Steven M. Clouse WRC Electrical System Improvements Phase 2A

Job No.: 21-6507

ADDENDUM 2

August 10, 2021

SHEET NO.
00E32
50 OF 328

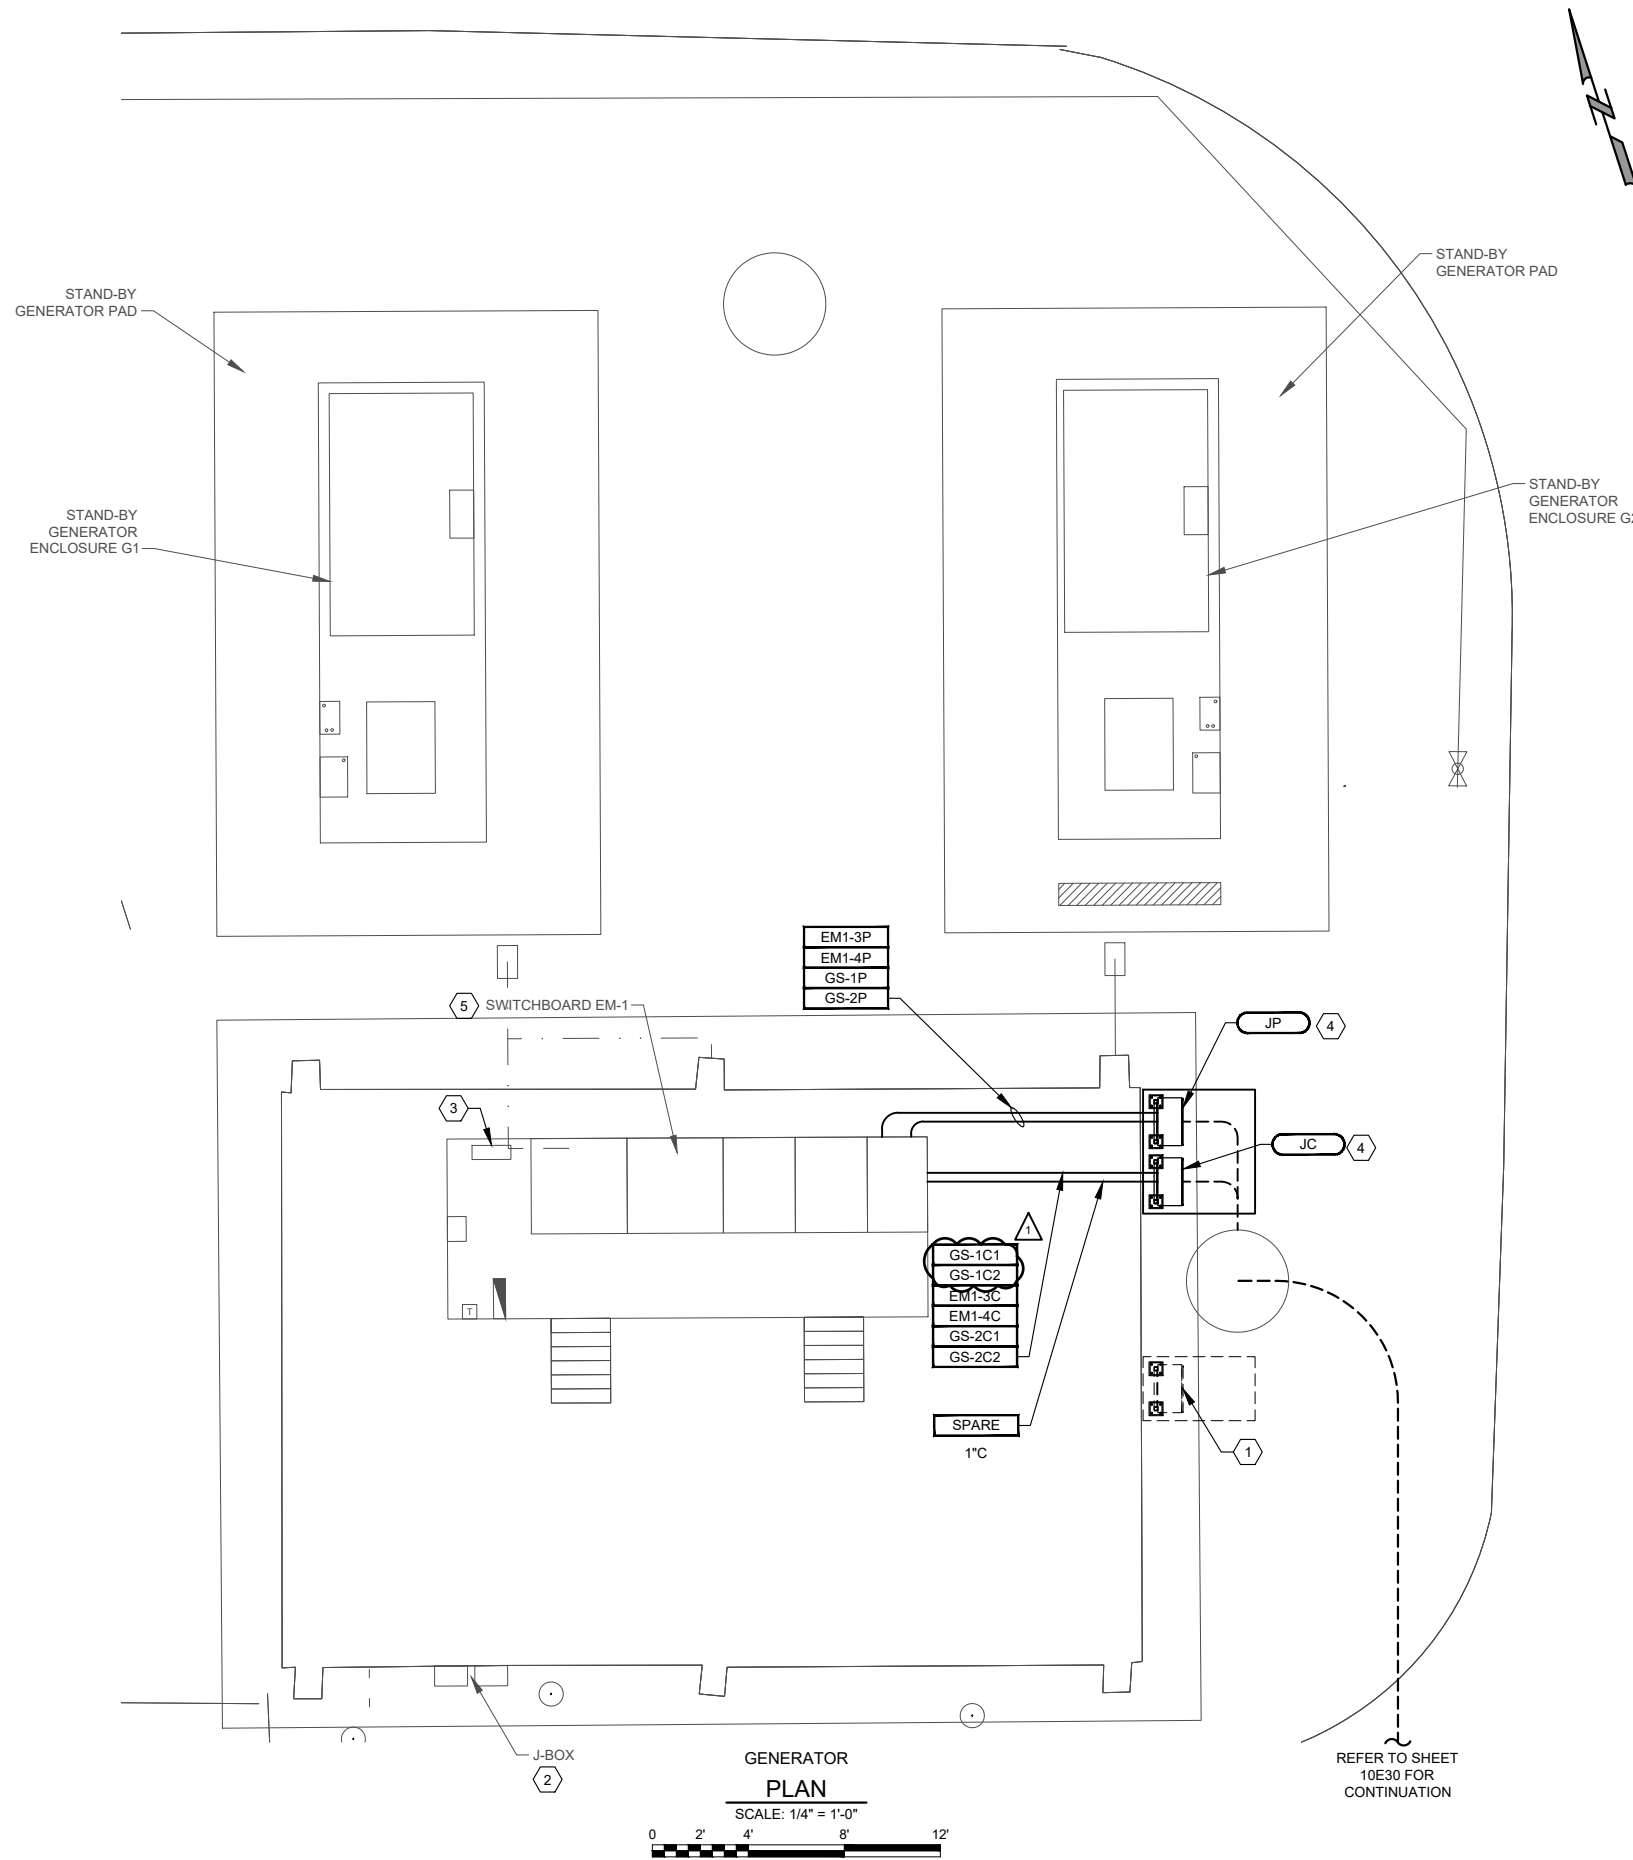
4. Sheet 00E32 GS-1C1 & GS-1C2 is missing from Junction Box JC to Switchboard EM-1.

Response: Add these two circuits to the conduits from the junction box to the switchboard. Refer to Changes to the Plans item "a. 00E32."

SHEET NO.
05E02
88 OF 328

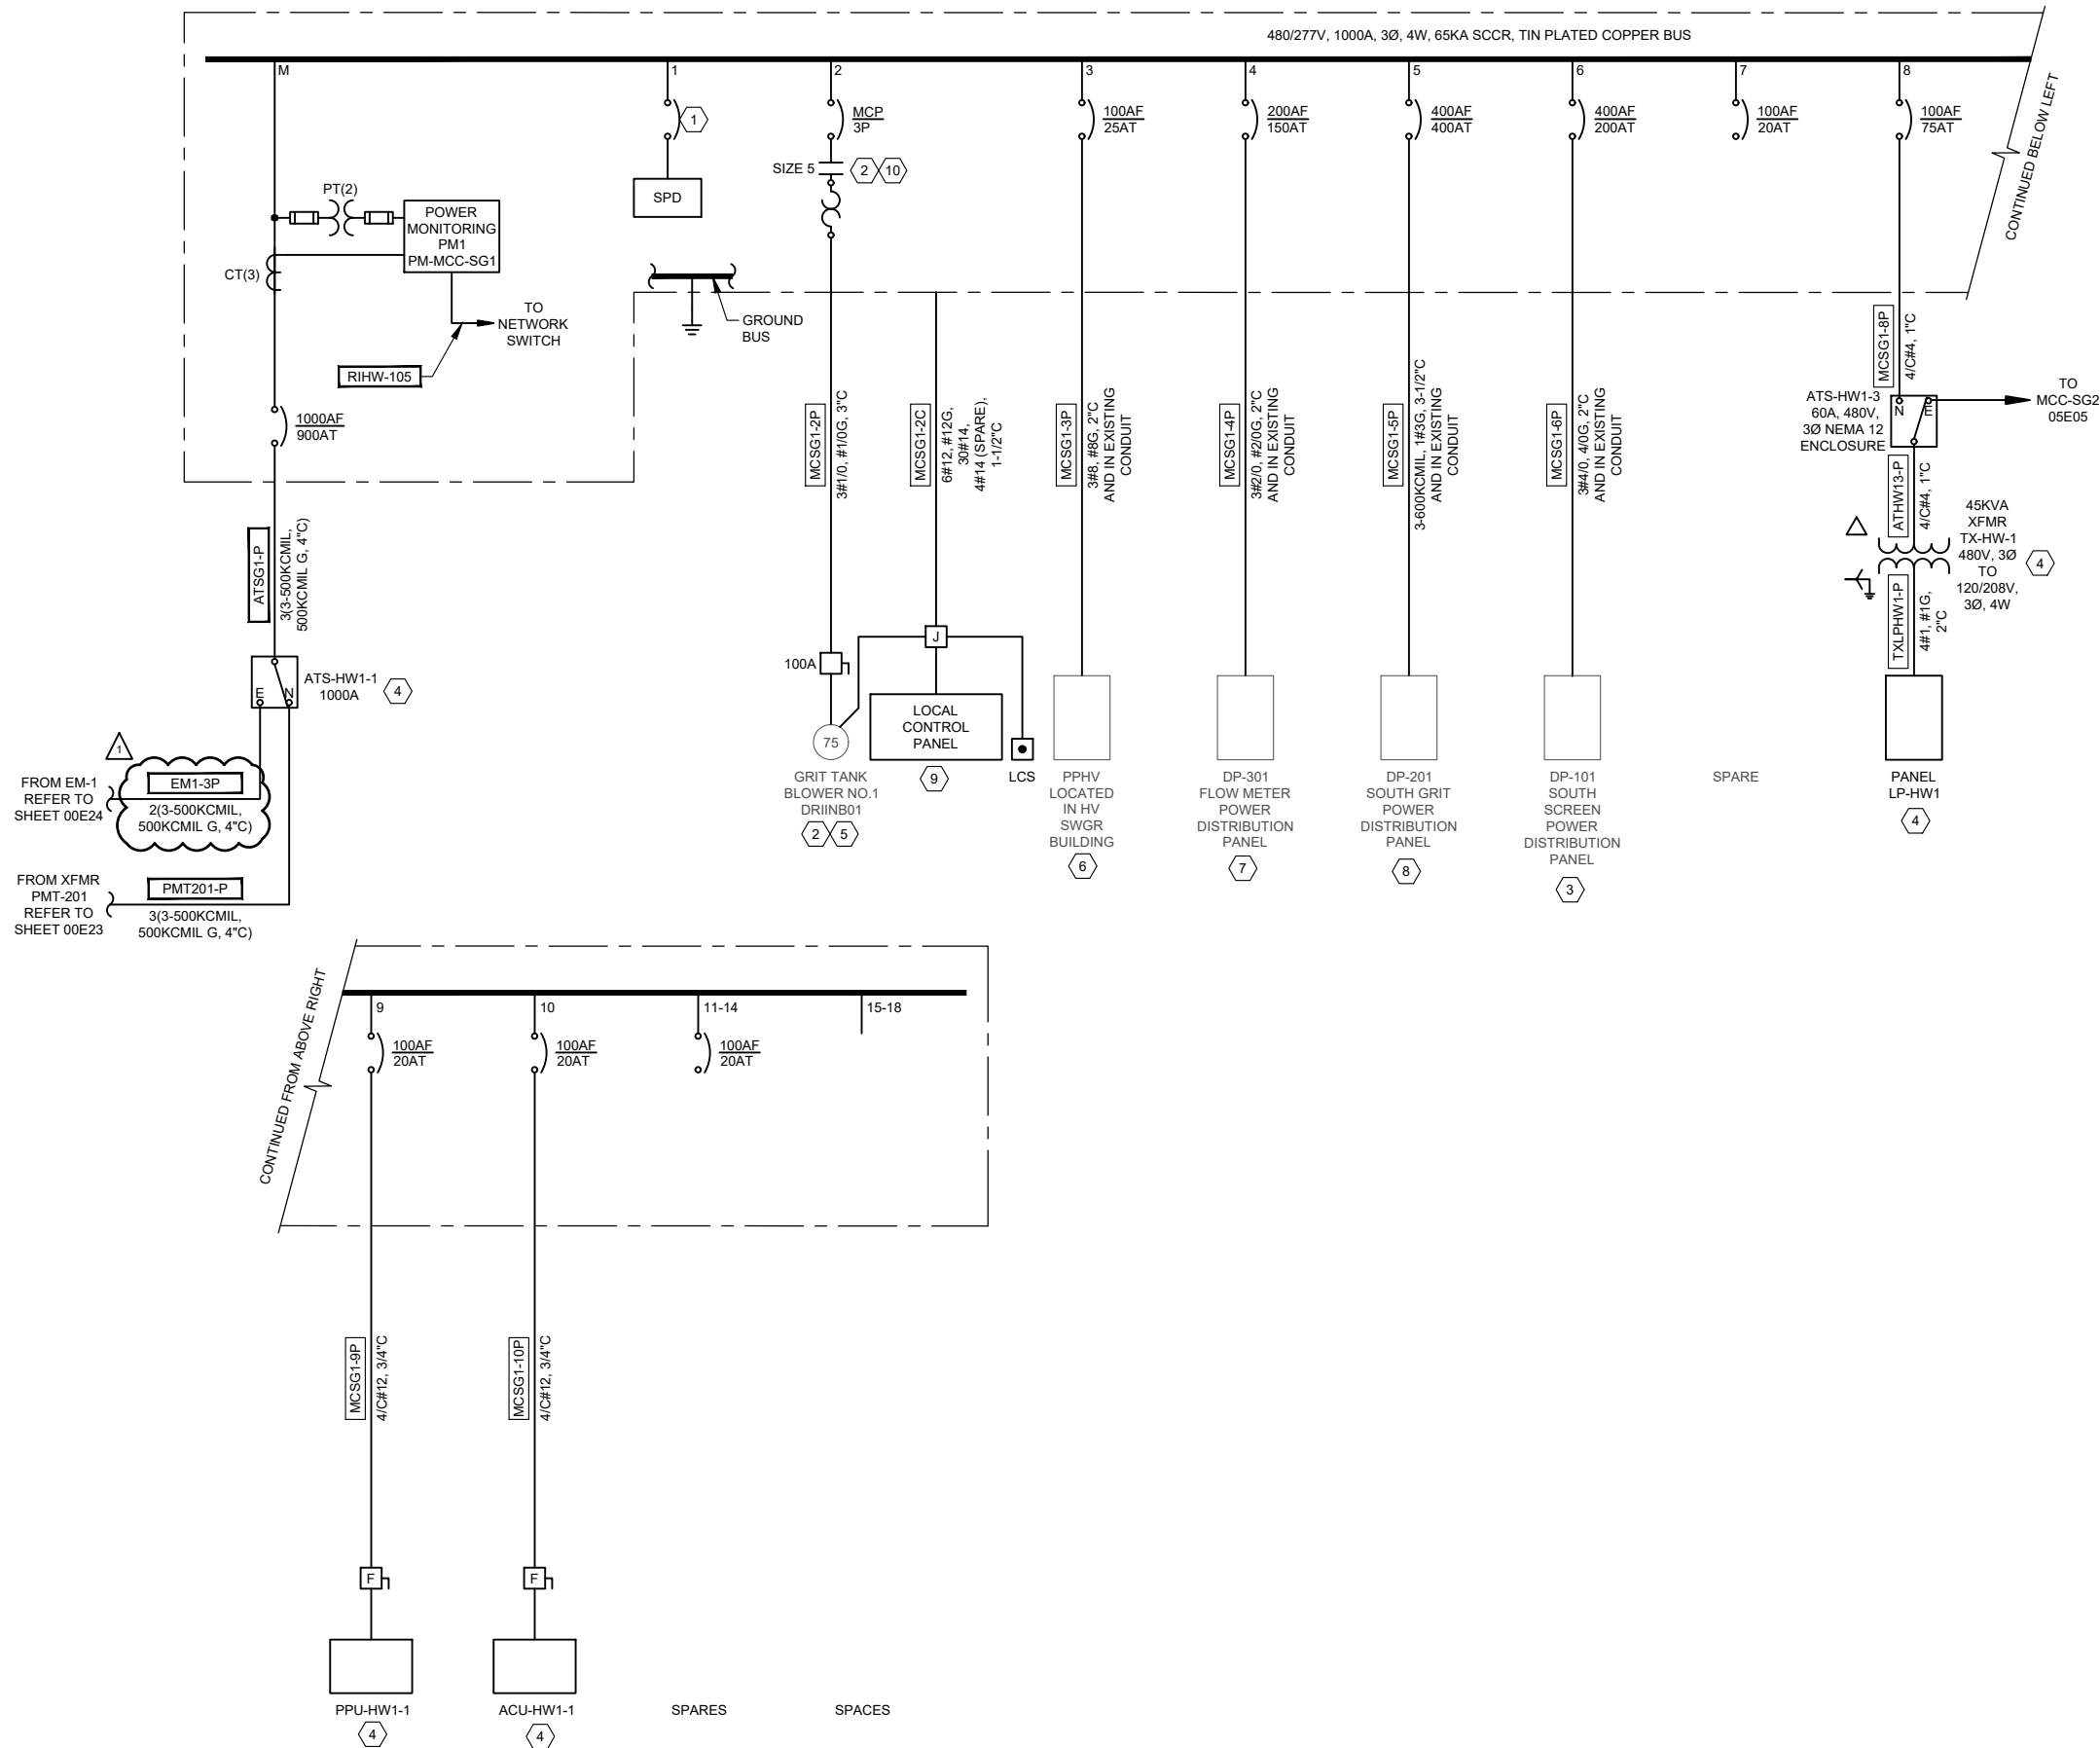
5. Sheet 05E02 DB section 05F, conduit #2 calls for 3-1/2" but conduit #7 is 3". Both conduits contain 3-#600 KCMIL & 1#3 AWG per one-line 05E04 & 05E05. Please review for consistency and advise.

Response: All referenced conduits are 3-1/2" as shown on the one-line diagram. Refer to Changes to Plans item "b. 05E02."

SHEET NO.
05E04
90 OF 328

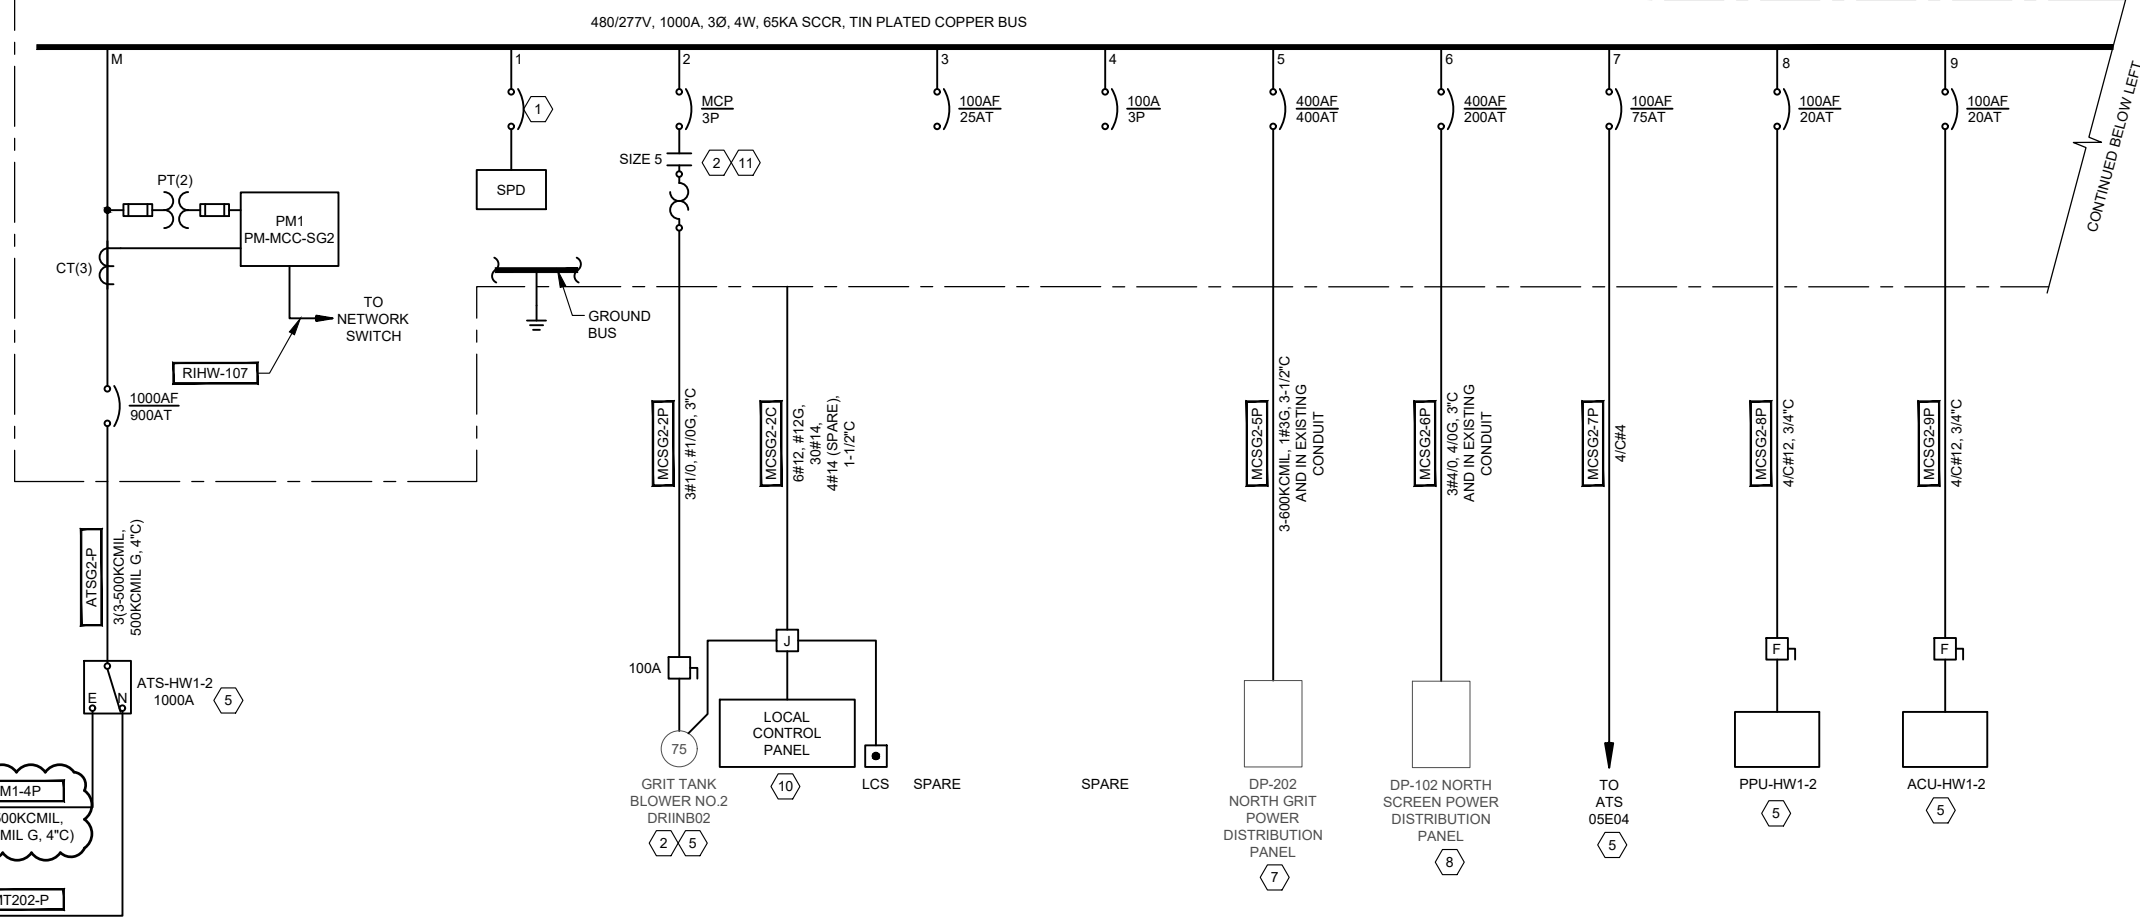
1. Please review routing of generator switchboard circuit EM1-3P to Headworks Electrical building. One-line diagram 05E04 sows it as 3(3-500KCMIL, 500KCMIL G). However, ductbank sections shows only 2 parallel feeds for this circuit. Sheet 10E33, DB section 10AM (4" conduit # 1-2), sheet 10E03, DB 10N (4" conduit # 1-2), sheet 05E02 DB 05C1 (3" conduit # 1-2), DB05C (3" conduit # 4-5). Please advise if the one-line is incorrect or the duct bank sections need to be revised. Also please review the conduit size, EM1-3P is shown as 3" in headworks ductbanks whereas EM1-4P is shown as 4" and both are shown in primary clarifier area as 4".

Response: This feeder is two parallel runs, 4" conduit. Refer to Changes to the Plans item "c. 05E04." (Sheet 05E02 sections already show 4" for this circuit.)
